## NOTIFICATION OF ADDENDUM ADDENDUM NO. TWO DATED: July 1, 2020

Parmer Ranch Partners L.P. on behalf of Northwest Williamson County Municipal Utility
District No. 2

#### Parmer Ranch Off-Site Wastewater Interceptor Wastewater System Drive Improvements

DETAIL SHOWING INSTALLATION OF GATE HINGES

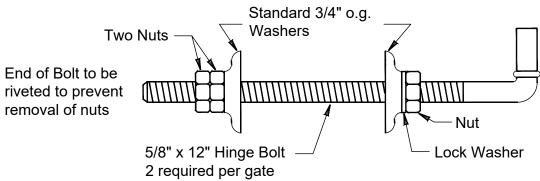
- 7. Will we be expected to install gates within the easement at each property fence for the WW line or are we to restore to existing condition upon completion? If a fence is required, can we get a detail?
  - Yes, gates are required at all fence crossing locations. A details is included as part of this addendum. A bid item has also been added. Gates will be installed at locations as directed by the Engineer and Owner in the field.
- 8. Can you provide the locations of the 6 construction entrances that are to be installed? Approximate gate locations have been added to the plans included with the Addendum.
- 9. Will spoils be allowed to be stockpiled on the Parmer Ranch Phase 1 project site or are all spoils to be hauled off for bid purposes?

Metal gate shall consist of 5 panels not less than 4'- 4" high and shall be aluminum or galvanized metal and of good quality. Gate and hardware shall meet the approval of the Engineer.
